**UNITED STATES OF AMERICA
BEFORE THE
FEDERAL ENERGY REGULATORY COMMISSION**

PJM Interconnection, L.L.C.)	Docket No. EL19-58-002;
)	ER19-1486-000
)	
)

COMMENTS OF THE INDEPENDENT MARKET MONITOR FOR PJM

Figure 1 Dispatch MW and actual generation: October 1, 2019

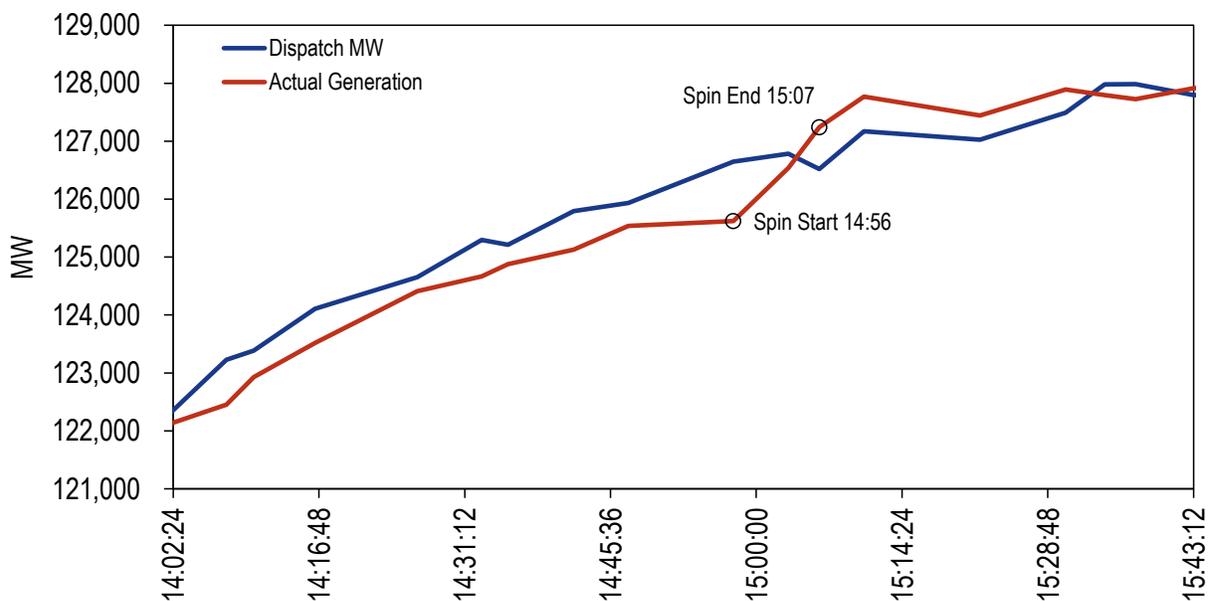
As an example, on October 1, 2019, during several intervals, PJM dispatched units to operate at a higher output to meet the greater than forecast load approaching the afternoon peak. Between 1425 EPT and 1455 EPT, at least 79 units failed to achieve the output level to which they were dispatched by PJM. On average, these units together failed to produce a total of 872 MW. The Area Control Error (ACE) at 1455 EPT was -1,064 MW, and at 1454

EPT these units together failed to produce 1,184 MW that they had submitted in their offers and that PJM had dispatched. The failure of these units to meet the output to which they were dispatched by PJM, following their submitted ramp rates, contributed to the low ACE on October 1, 2019. PJM declared a synchronized event at 1456 EPT for low ACE to maintain power balance.

Figure 1 compares the MW dispatched by PJM and the actual output provided by resources on October 1, 2019.⁴

Units did not meet their offered maximum output levels in some cases as a result of ambient conditions, e.g. higher temperatures and higher humidity, for which units had not taken partial forced outages. In addition, combined cycle plants did not meet their offered maximum output levels because the deployment of the power augmentation measures required to increase output (e.g. duct firing, water or steam injection, over firing) was either

The May 21st Order (at P 273) requires PJM to address "the difficulties associated with predicting [reserve] capability for certain resource types, based on configurations or whether they contain duct burners." PJM fails to address the issues that the May 21st Order required PJM to address. The low ACE events demonstrate that PJM's dispatch is not able to accurately model the MW available to provide energy and reserves because the PJM software does not incorporate the real world discontinuities in plant ramp capability. Correctly measuring reserve capability and joint optimization with energy dispatch requires software changes to correctly model equipment configurations, ramp rates, and dispatch timing. Such capability must be developed and implemented in order for PJM to comply with the applicable directives.

Figure 2 PJM real-time market dispatch timing for one target time

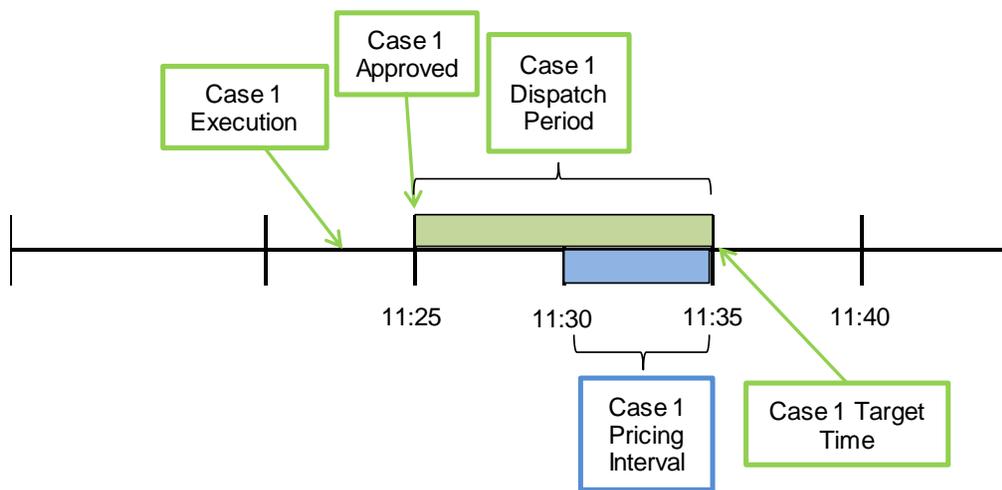
Figure 2 depicts the timing of the real-time dispatch under the status quo and PJM’s proposed changes that were approved by the PJM Members Committee on July 23, 2020. In this scenario, PJM approves a case (Case 1) at 11:25 for target time 11:35 that sends dispatch signals to resources at 11:25, when the case is approved. The LMPs and reserve clearing prices that are calculated using the energy and reserve dispatch solution from Case 1 apply to the five minute interval between 11:30 and 11:35 with the recently approved changes.

Figure 3 PJM real-time market dispatch timing for consecutive target times

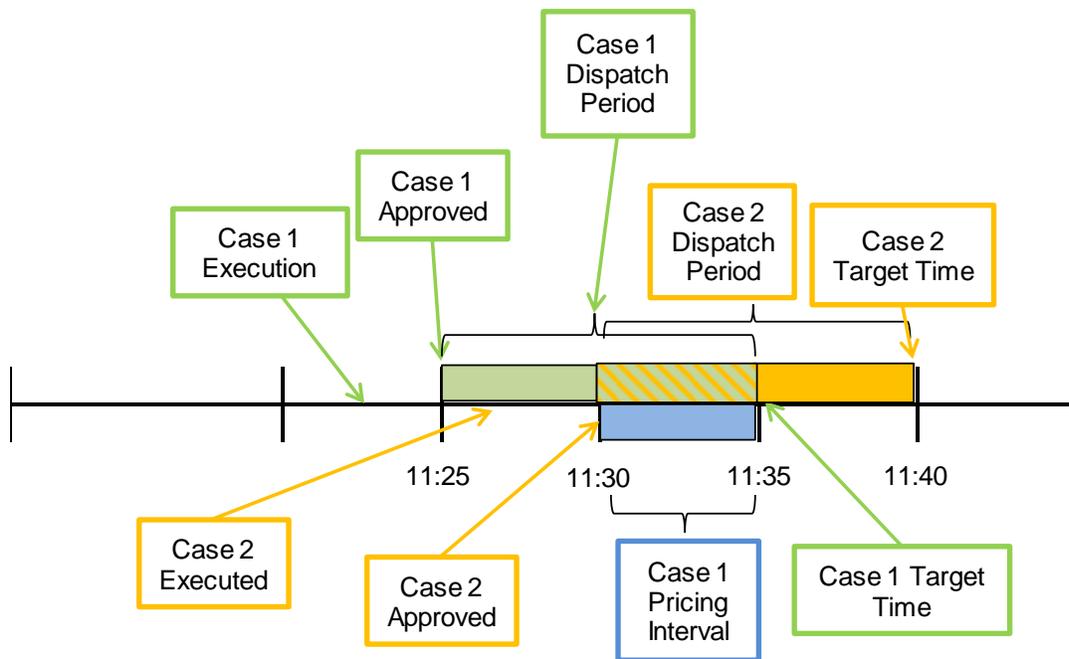
According to changes approved by stakeholders, PJM would settle reserves from five to ten minutes after sending the dispatch instruction. During this five minute interval, PJM will have already sent a new dispatch instruction that, in many cases, will contradict the dispatch instruction corresponding to the settlement, as depicted in Figure 3.

In the scenario shown in Figure 3, PJM approves another case (Case 2) at 11:30 for target time 11:40 that sends revised dispatch signals to resources at 11:30, when Case 2 is approved. From 11:30 to 11:35, resources are expected to follow the dispatch instructions from Case 2, while the LMPs and ancillary service prices are calculated using Case 1.

PJM would pay a resource that cleared reserves while that resource follows a new dispatch signal in which it may not have cleared reserves or cleared a different quantity of reserves. The incorrect compensation extends to the five minute uplift payments that PJM

will pay under the May 21st Order. The result is not logical. In fact, PJM's five minute dispatch and pricing process would result in consistently unmatched dispatch and pricing signals. The only logical solution is to dispatch, clear, and settle reserves for one single five minute period. This requires shortening PJM's dispatch timeframe from 10 minutes to 5 minutes.

Figure 4 Corrected real-time market dispatch timing

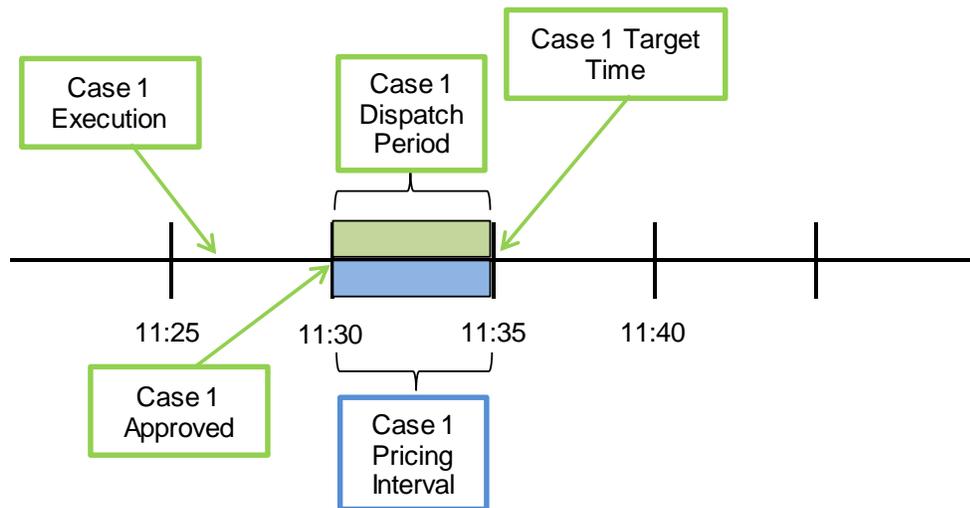
PJM should not implement the reserve market changes without correcting the overlapping dispatch periods. When the dispatch periods overlap, resources that need to reduce output to provide reserves do not have time to reach the target reserve level before a new signal comes. Under the extended ORDC, reserve prices and corresponding LMPs are based on the reserve targets, not what is actually provided. The dispatch overlap creates a

situation where customers will pay higher prices for reserves that resources following PJM's dispatch instructions would not achieve. (The resources are physically capable, but PJM's signals will not lead them to meet the cleared reserves.) A correct five minute market timeline, with a reduced ramp time of five minutes, as shown in Figure 4, would eliminate the overlapping dispatch periods. PJM must resolve this issue, which it has defined as a long term issue, in order for the reserve market design changes to function as intended.¹⁰
